**PLANNING AND DEVELOPMENT SERVICES STAFF REPORT**

**For Planning Commission Meeting of June 16, 2009**

**SUBJECT: Near North PUD Zoning District and PUD Site Plan  
(626-724 North Main Street) File No. SP08-023**

Before

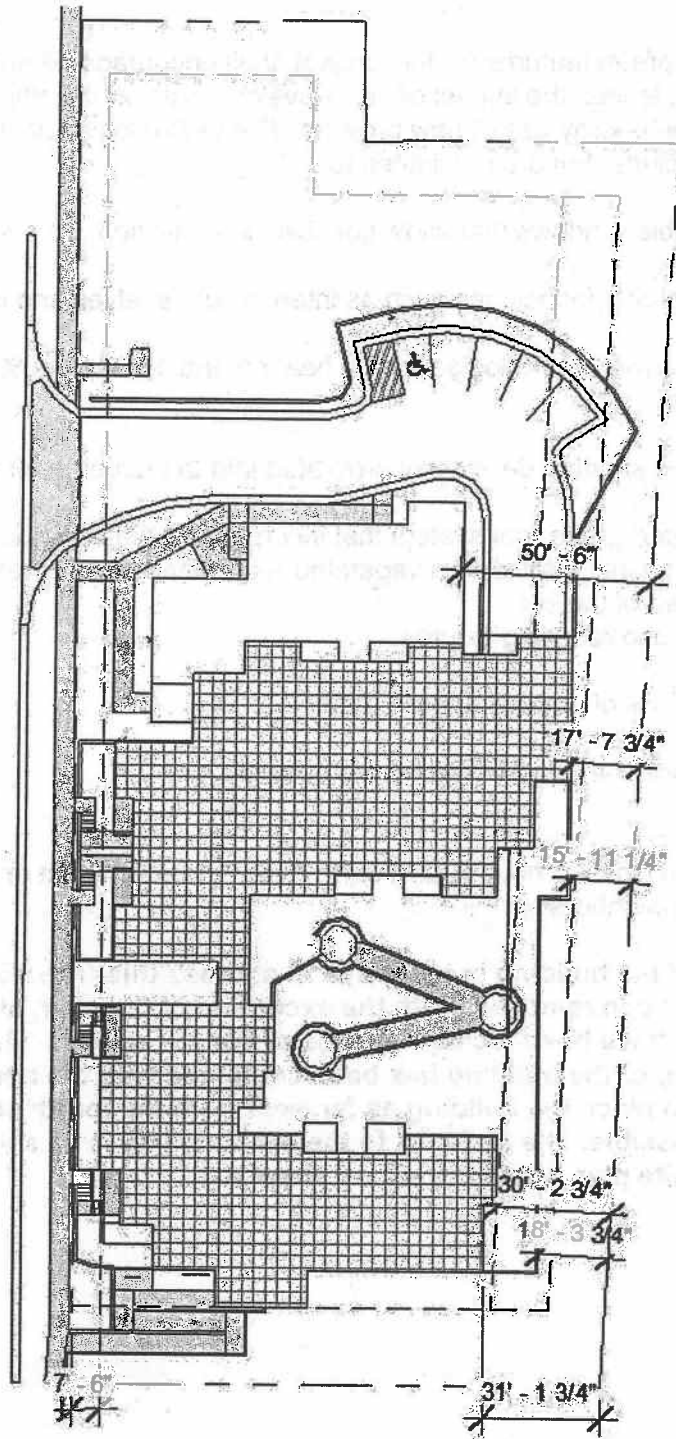
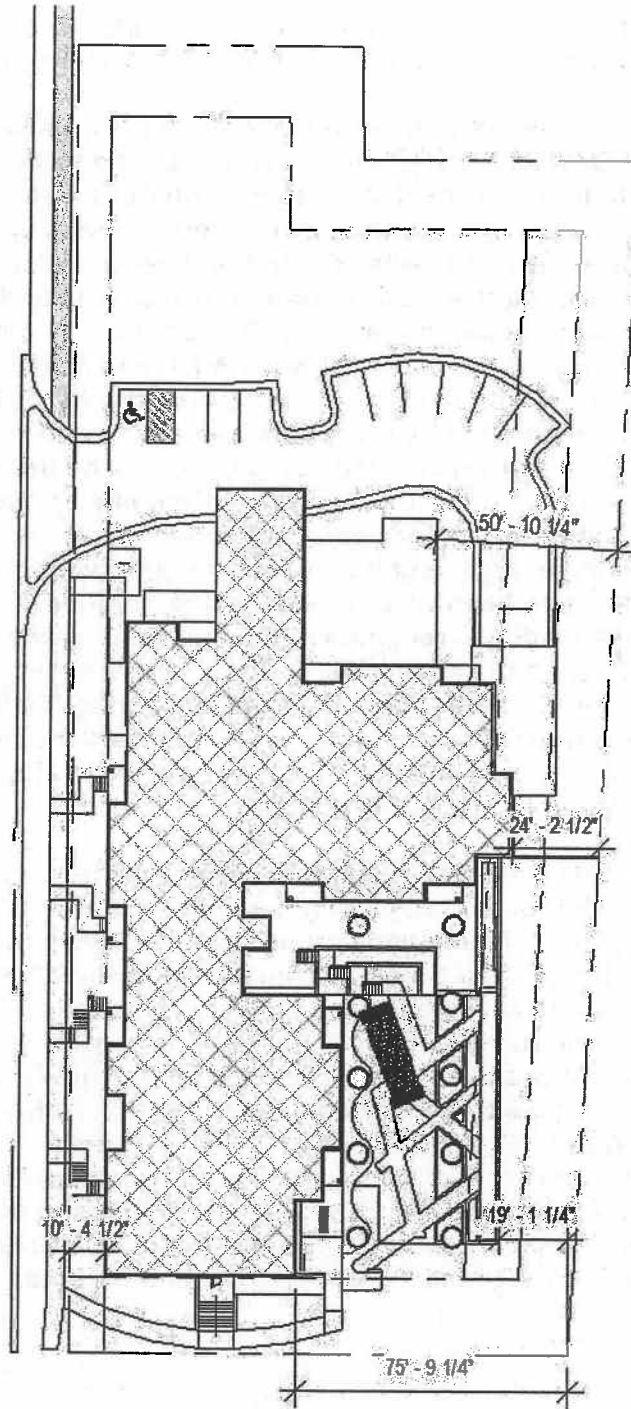
- i. Operable windows that allow passive air ventilation.
  - ii. Day lighting techniques such as internal light shelves and large windows.
  - iii. Geothermal technologies for the heating and cooling 100% of the building.
  - iv. Passive shading devices incorporated into the structure of the building.
  - v. A planted green roof system that incorporates the necessary detention for storm events, providing a vegetated roof surface that covers over 50% of the area of the site.
  - vi. Water use reducing fixtures
  - vii. Over 70% of parking underground.
  - viii. Pervious Parking Surface where possible.
5. Rear setbacks are too close to houses on Fourth Ave. Address height and privacy impacts on adjacent neighbors.

**We have revised the building in two ways to address this. The North East corner has been removed. With the exception of the stair, all residential units have been located outside of the 30' setback. The entire south wing of the building has been combined with the north-south corridor to place the building as far west from the fourth street neighbors as possible. The distance to the property line is as shown within the new site plan submittal set on sheet A-1.**
